From: ben whitby <benwhitby15@yahoo.co.uk>
Sent: 23 January 2012 18:52
To: Hannah Barker
Subject: Re: 61 Berriedale Drive - AWDM/0078/12
Attachments: 02 Proposed Plans and Elevations Rev B LDC Layout1 (1).pdf

Project:
Proposed Rear Extension
At:
61 Berriedale Drive
Lancing
West Sussex
BN15 0LD

Drawing title:
Plans & Elevations As Proposed
Incl. Section A–A

Scale: 1:100 1:50 | Paper size: A1
Date: 9.1.2012 | Drawn: BJW
Drg. No. 02 | Rev'n B

West (Side) Facing Elevation **Rear (North) Facing Elevation** **East (Side) Facing Elevation**

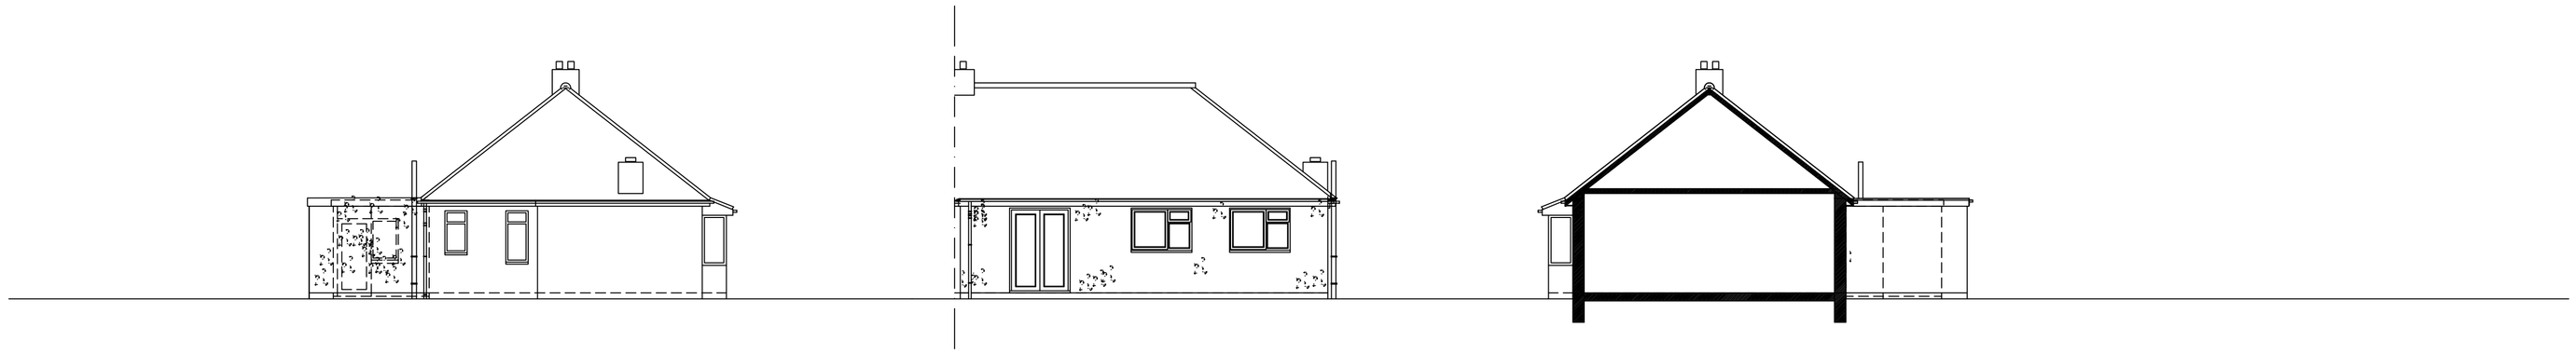
I have just been considering your application for lawful development. I do not consider that the proposal is permitted development as the eaves of the proposed extension exceed the height of the existing eaves. (Eaves height is measured from the ground level at the base of the outside wall to the point where that wall would meet the upper surface of the flat roof.)

Please could you let me know how you would like to proceed on this matter? You can withdraw the current application and submit a full planning application with a fee of £150. Or you could amend the plans to show the eaves of the extension at a lower level than the existing eaves and the proposal will therefore be considered to be permitted development.

Please find attached our revised drawing with lower eaves height.
I trust this is now satisfactory under the current pd application and look forward to approval.
